RESEARCH REACTOR CENTER

SUBJECT: Written communication as specified by 10 CFR 50.4(b)(1) regarding responses to the “University of Missouri at Columbia - Request for Additional Information Regarding the Renewal of Facility Operating License No. R-103 for the University of Missouri at Columbia Research Reactor (TAC No. ME1580),” dated April 17, 2015

Attached are responses to the April 17, 2015, request for additional information, which were in the form of ten (10) questions.

Figure 1 – Reactor Power, Fuel and Cladding Temperatures vs. Time
for a Positive Reactivity Step Insertion of 0.006 Δk/k

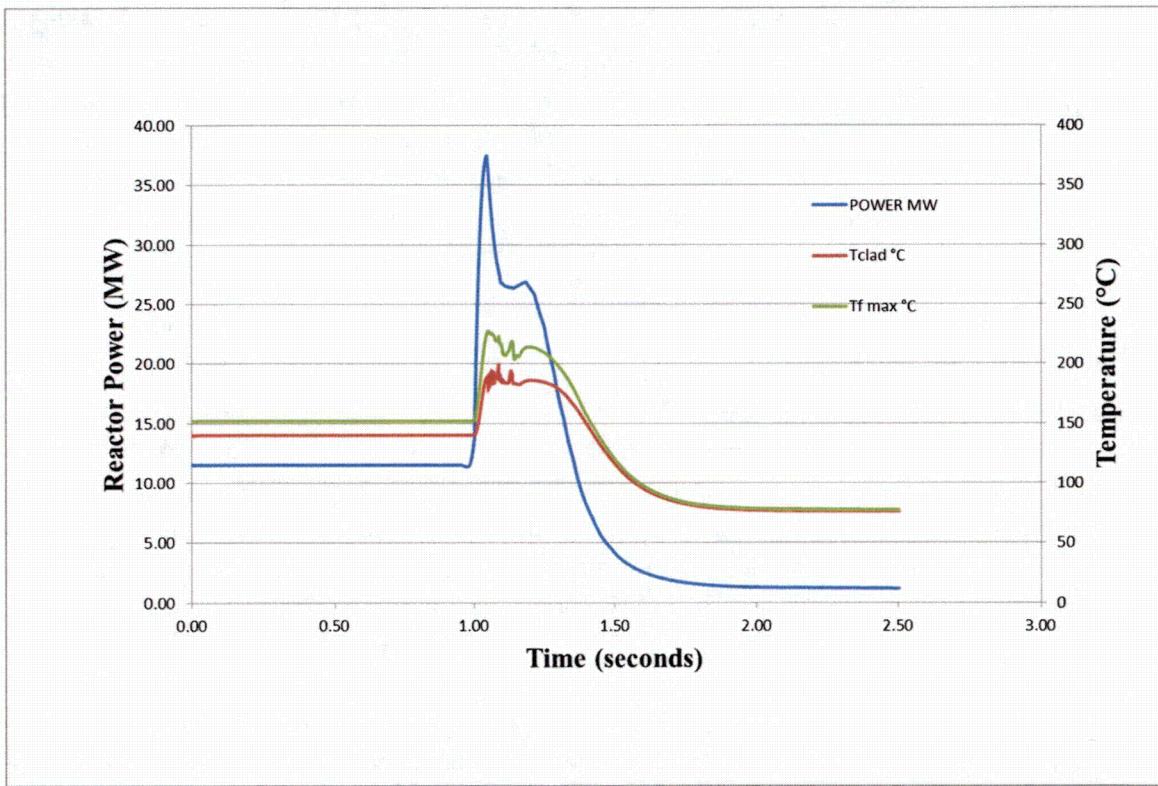
- a. *Regarding Insertion of Excess Reactivity - The initial power is 10 MW rather than the Limiting Safety System Setting setpoint in TS 2.2 (12.5 MW). The temperature feedback coefficient used is $-7.0 \times 10^{-5} \Delta k/k$ rather than the TS 5.3.a value of $-6 \times 10^{-5} \Delta k/k$. It is unclear what peaking factors are employed. SAR Figure 13.2 seems to indicate that the scram time used is faster than the value in TS 3.2.c. The acceptability of the results is based upon whether the power for burnout is achieved rather than the safety limit identified in TS 2.1. Provide additional information justifying and supporting the analysis and the safety conclusions or provide a justification for why such information is not required.*

The results of a step reactivity insertion of 600 pcm (+0.006 Δk/k) are shown below in Figure 1. As expected, due to the higher starting core power level, much lower core coolant flow rate and much higher than normal core coolant inlet temperature conditions assumed for this updated analysis, the peak power during the transient momentarily reaches approximately 37.4 MW compared to a value of approximately 33.0 MW reported in the SAR analysis for the same 600 pcm step reactivity insertion.

Several SPERT tests had shown that the reactor can withstand such short duration (few milliseconds) power burst without sustaining any fuel damage and only sustained operation at such high power levels will lead to fuel damage. The peak fuel temperature reached during the Insertion of Excess Reactivity accident in the worst (Hot) channel is only 227.4 °C – well below the new Safety Limit of 530 °C for the aluminide fuel.

Figure 1 – In-Pool Portion of the Primary Coolant System
(with RELAP Model components identified)

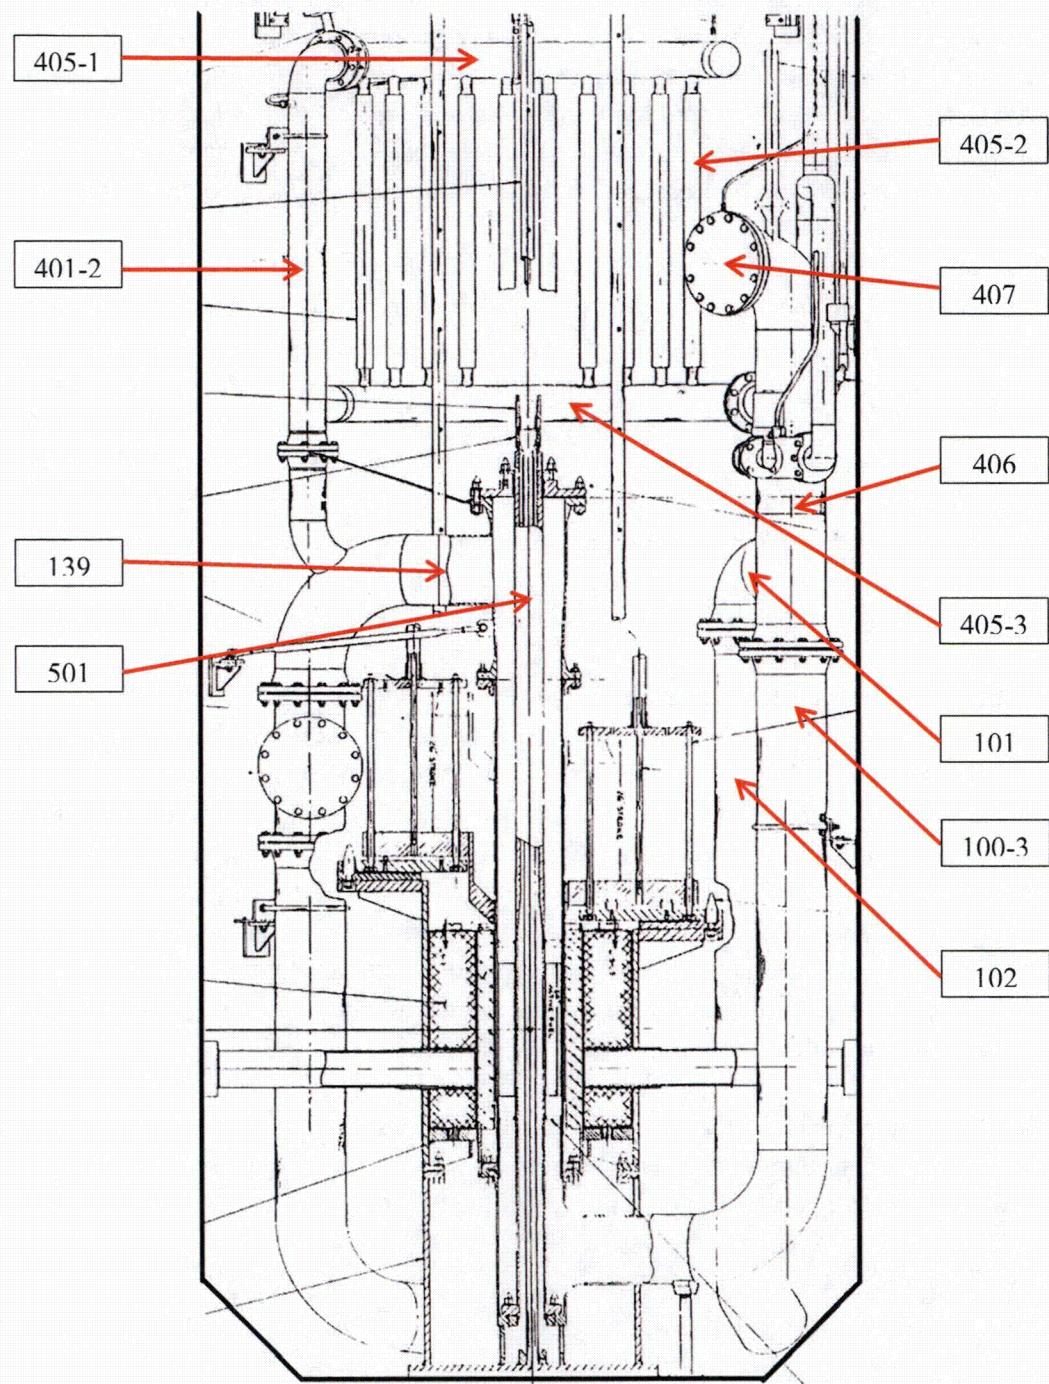
8. NUREG-1537, Section 13.1.3, "Loss of Coolant," provides guidance to the licensee to consider the consequences of a loss of coolant accident (LOCA). MURR SAR Section 13.2.3.2 describes the LOCA event for the loss of the PCS integrity, and states that the accident of greatest consequence is a rupture in the short section of the PCS piping (either the cold leg or the hot leg) between the reactor pool and either isolation valves (507B or 507A). The SAR describes the consequences of a cold leg break between the isolation valve 507B and the reactor pool in significant detail. The hot leg break discussion is more succinct. The SAR also states that how "the anti-siphon system ensures that the core remains covered differs depending on the location of the rupture."

Key PCS components for the LOFA and LOCA are described in Table 1 along with their RELAP Model component number. These components are also indicated in the vertical cross-sectional view of the reactor pool and in-pool portion of the PCS (Figure 1).

With no pipe break occurring in the PCS during a LOFA, all of the above sections of the PCS stay filled with primary coolant. This results in the development of the natural circulation flow path described in Paragraph 2 of the above question. However, for the hot-leg break LOCA, a double shear on the inlet and outlet sides of the hot-leg isolation valve is assumed, such that the hot-leg isolation valve is functionally eliminated. With anti-siphon system air being injected into component 406, voiding starts at the higher elevated connected PCS components as indicated in Table 1 and Figure 1. With the air rising vertically, the following occurs:
